LAUREATE PARK ELEMENTARY SCHOOL

SUMMARY

<p>Owner Barbara M. Jenkins Orange County Public Schools</p> <p>Applicant Tyrone K. Smith, AICP Orange County Public Schools</p> <p>Project Planner Colandra Jones, AICP</p>	<p>Property Location: The subject property is generally located at the southwest corner of Laureate Boulevard and Kellogg Avenue (±13.1 acres, District 1).</p> <p>Applicant's Request: Specific Parcel Master Plan (SPMP) approval for a 111,289 square foot elementary school within the Laureate Park neighborhood.</p> <p>Staff's Recommendation: Approval of the request, subject to the conditions in this report.</p>	
<p>Updated: May 31, 2016</p>

DEVELOPMENT PLAN

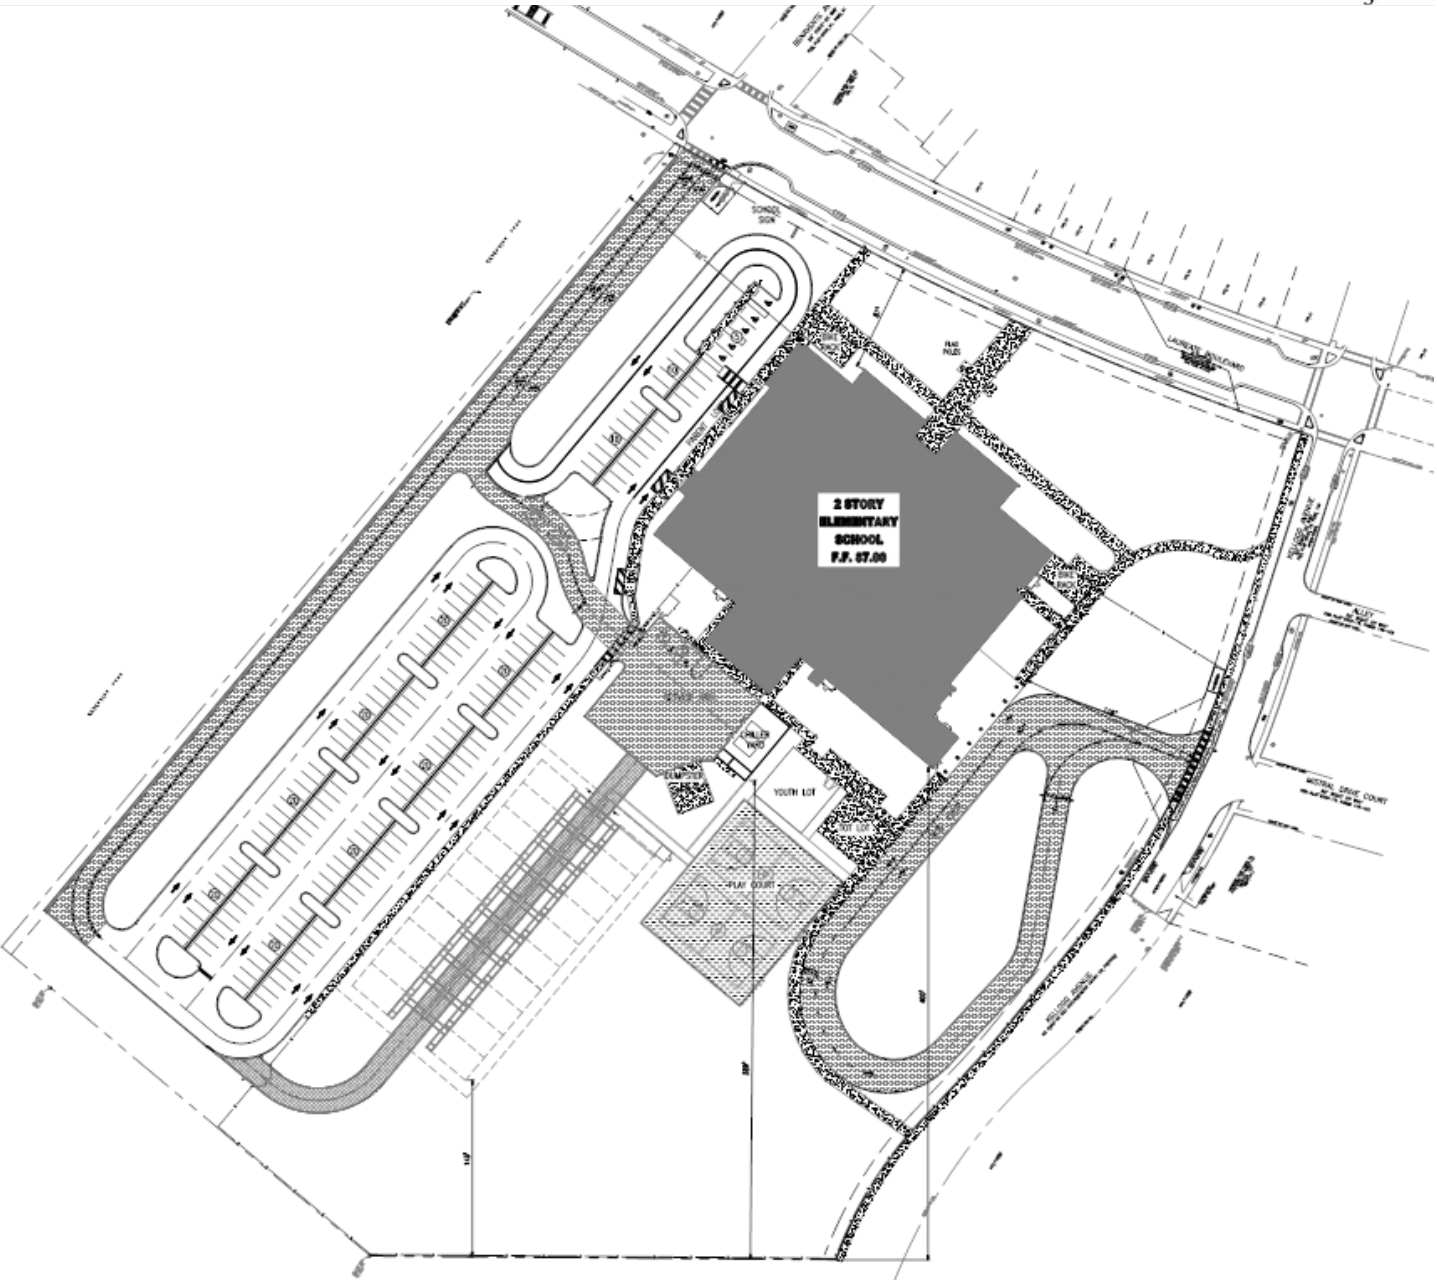
Please consider relocating the dumpster away from the play court area.

Please consider adding a flare to the edge of the western walkway and primary walkway where it meets the sidewalk located on Laureate Boulevard.

Please consider adding a crosswalk into the main parking area located in the southwest area of the site plan. Adding a crosswalk from the walkway into the main parking area will provide a clear and safe path of travel for faculty and students.

FRONT ELEVATION

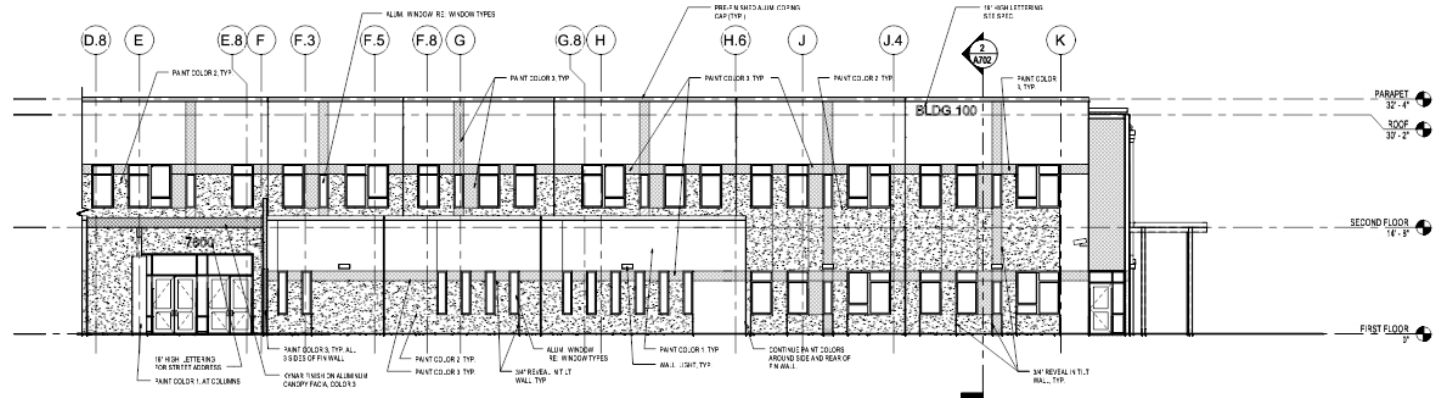
Consider centering school sign over entrance to the school, as viewed from the street. The entrance to the school is relatively obscured and doesn't read throughout the building - the sign cue may help to better define the pedestrian entrance.
